Illinois Tollway Base Sheet Revisions			
Section M	Base Sheet Drawings		
	Drawing	Modification Summary	Effective: 03-31-2016
	All	The electronic (pdf) version of the Standard Drawing are now made searchable (text).	
Erosion Sediment Control (ESC)-Series 200			
M-ESC-205	Sediment Basin Dewatering Device		
	Revised Note 7, removed proprietary name from skimmer device.		
Roadway (RDY)-Series 400			
M-RDY-408	Approach Slab, Mainline		
All	Changed Transverse Reinforcement size and spacing in the bottom mat of the bridge approach slab and transition approach shoulder slabs from #6@9" to #8@4" to be in conformance with IDOT ABD Memo 15.8.		
All	Changed Transverse Reinforcement size and spacing in the top mat of the bridge approach slab and transition approach shoulder slabs from #5@12" to #5@6" to be in conformance with IDOT ABD Memo 15.8.		
All	Changed Longitudinal Reinforcement size and spacing in the top mat of the bridge approach slab and transition approach shoulder slabs from #4@15" to #5@6" to be in conformance with IDOT ABD Memo 15.8.

Tollway Base Sheet Revisions		
Section M	Base Sheet Drawings	
	Drawing	Modification Summary Effective: 03-31-2016
	Maintenance of Traffic (MOT)-Ser

M-ITS-1100

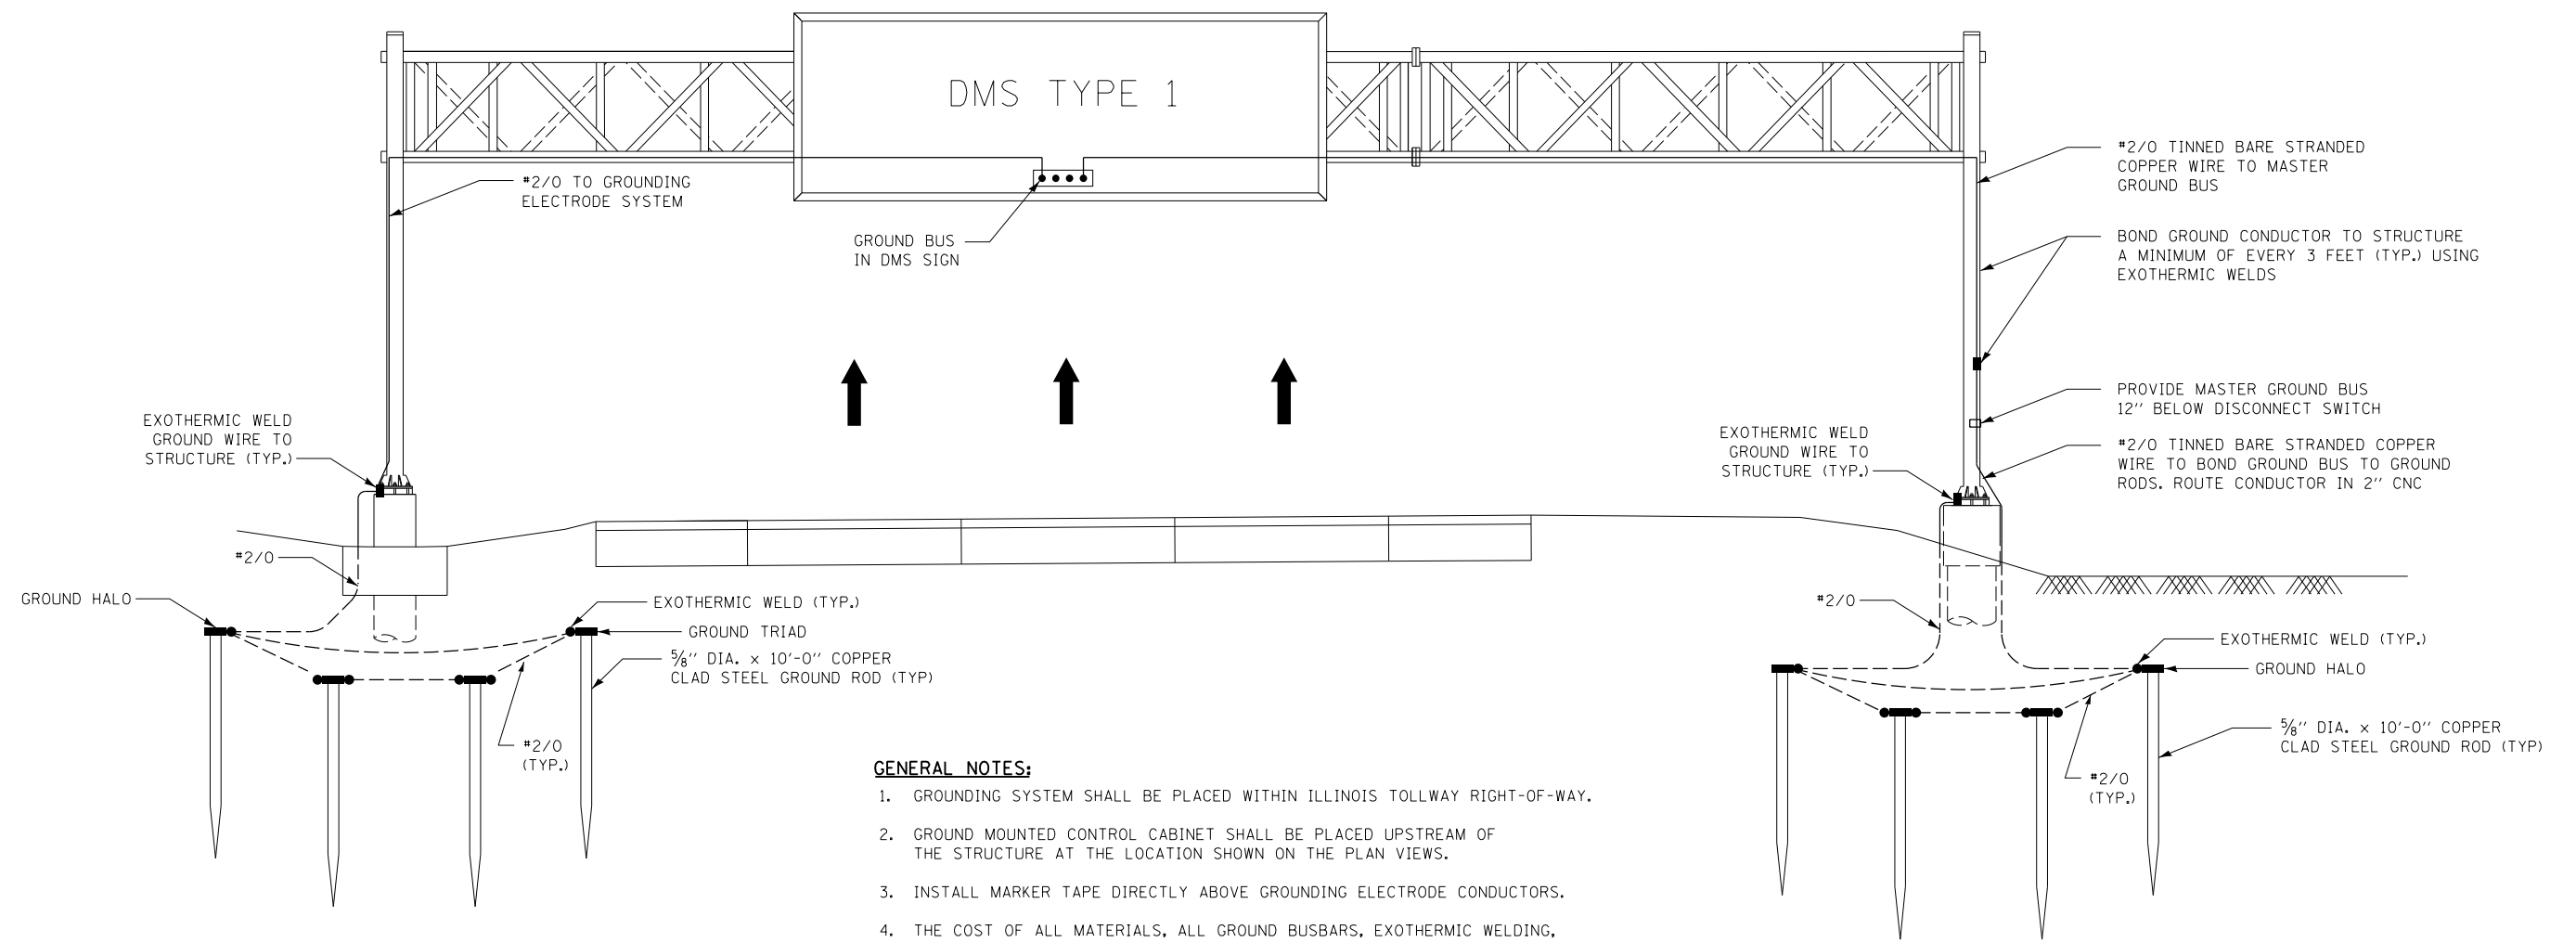
New Sheet
